A G E N D A

Architectural Review Board

April 23, 2019

1918 Ridge Avenue

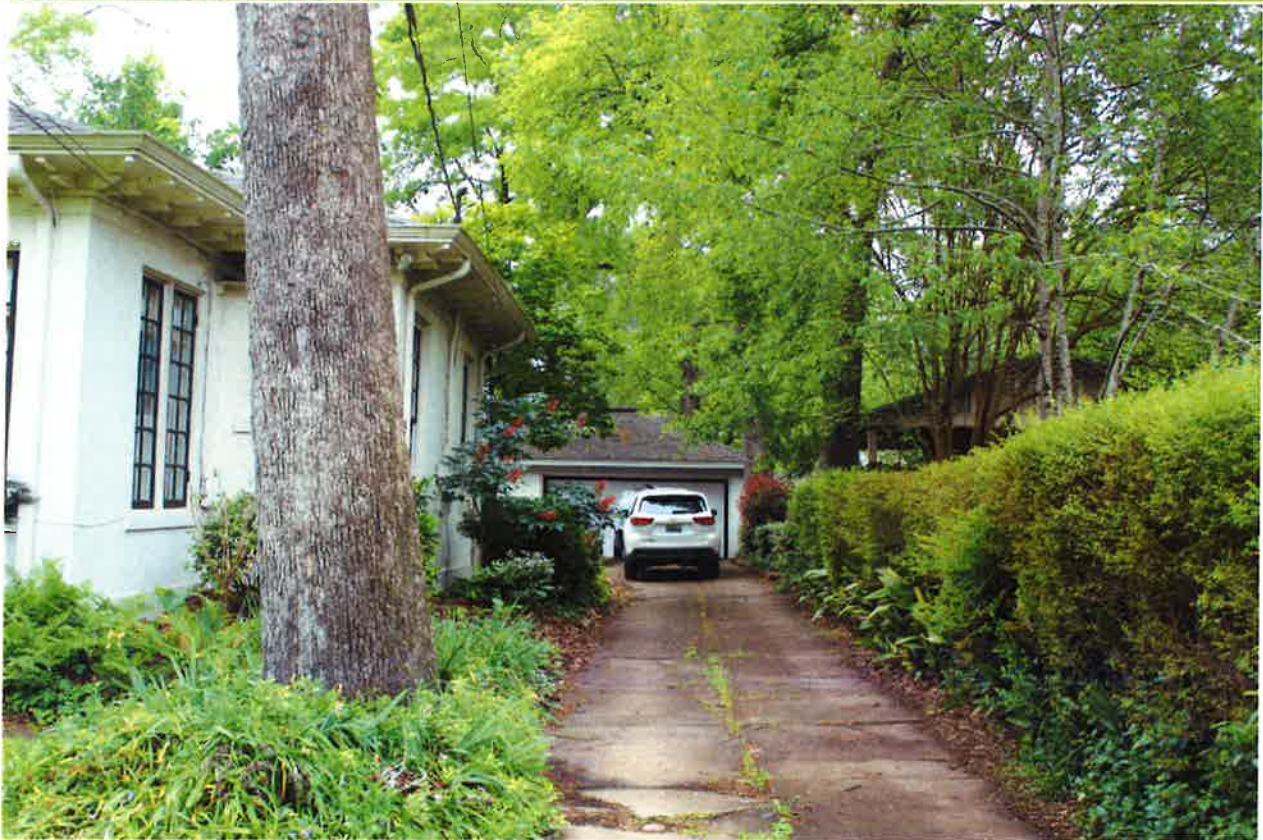
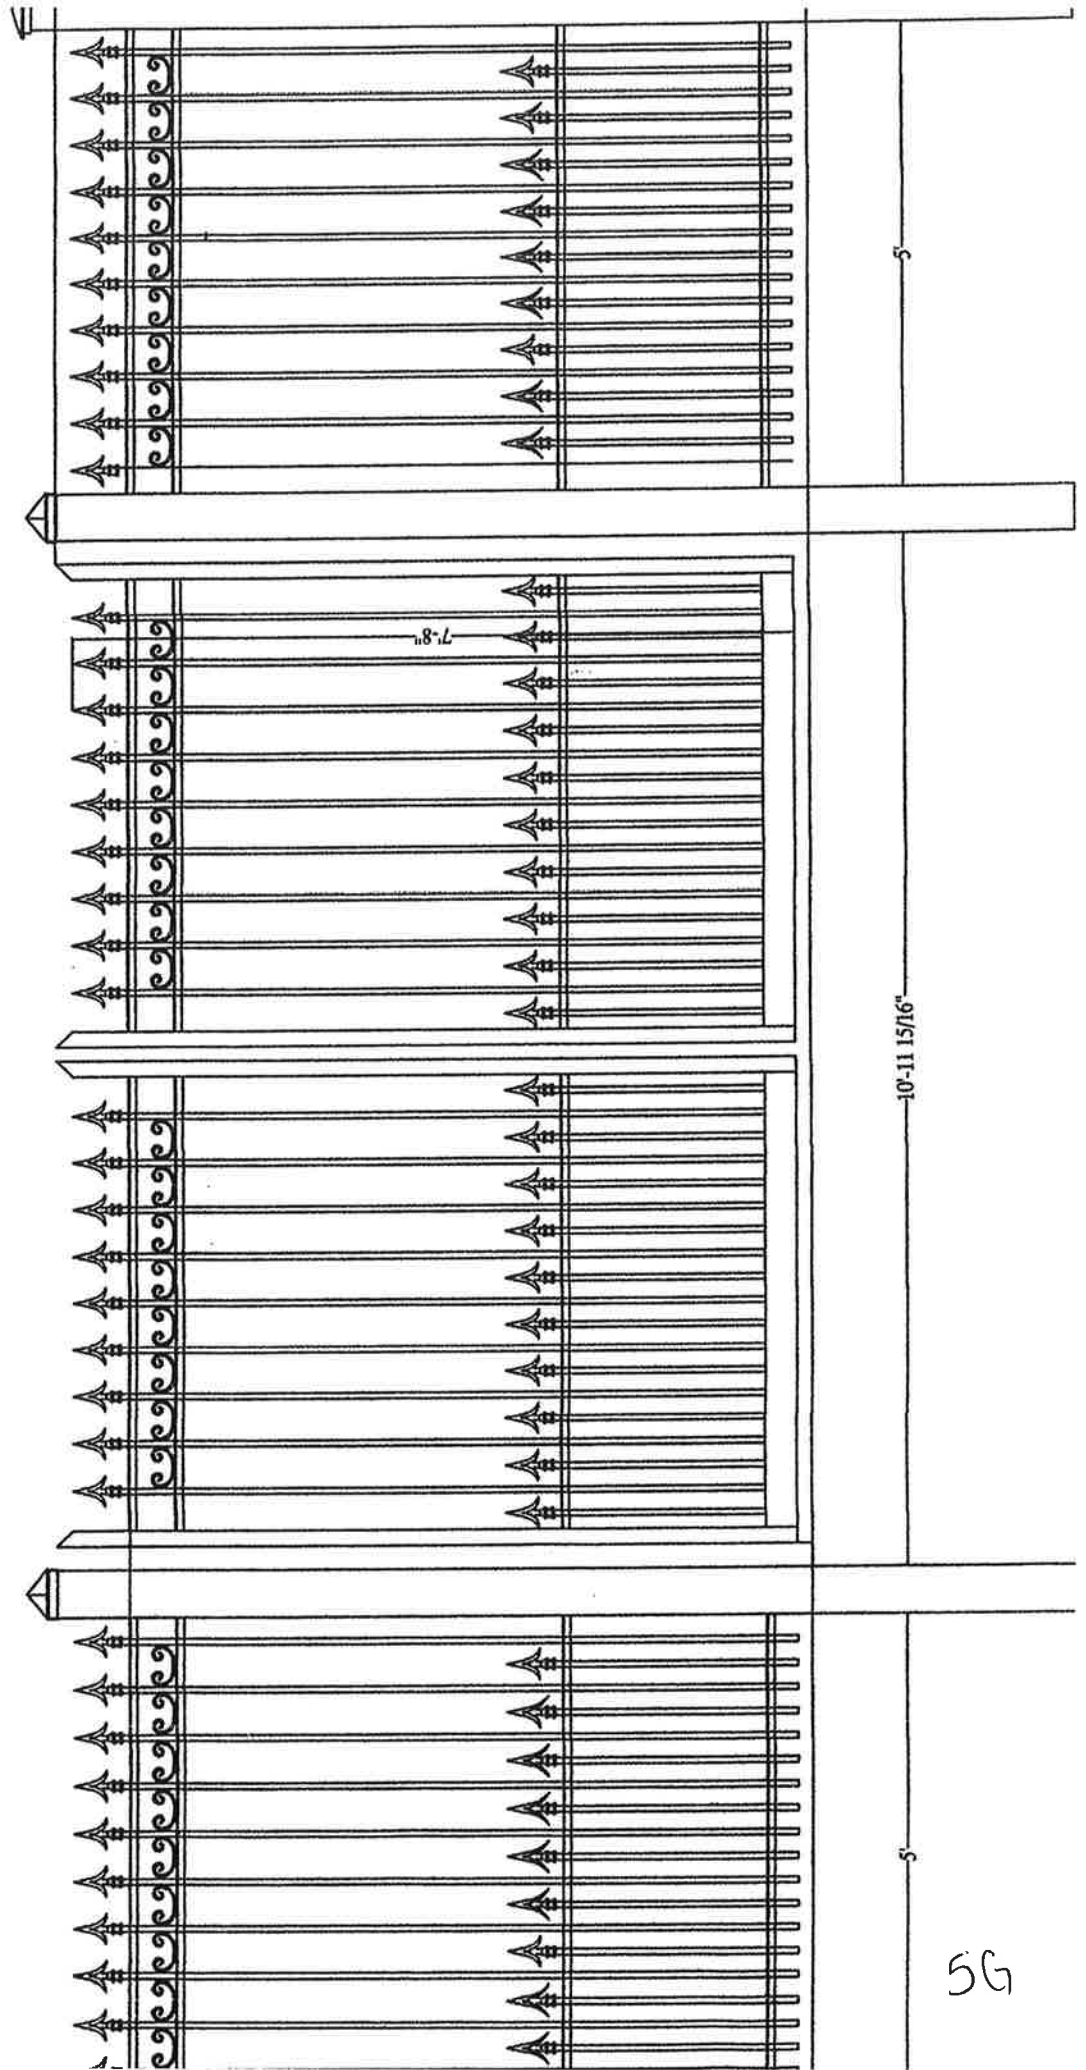
- The Board has generally requested that privacy fences with returns to the house be set back from the front building line. The petitioner is attempting to help obstruct a direct view into their living space at the corner, the Board could allow the property line fence to come forward, and consider setting the driveway gate back to the corner of the first projection.
- Standard replacement size for a tree is 2.5" caliper
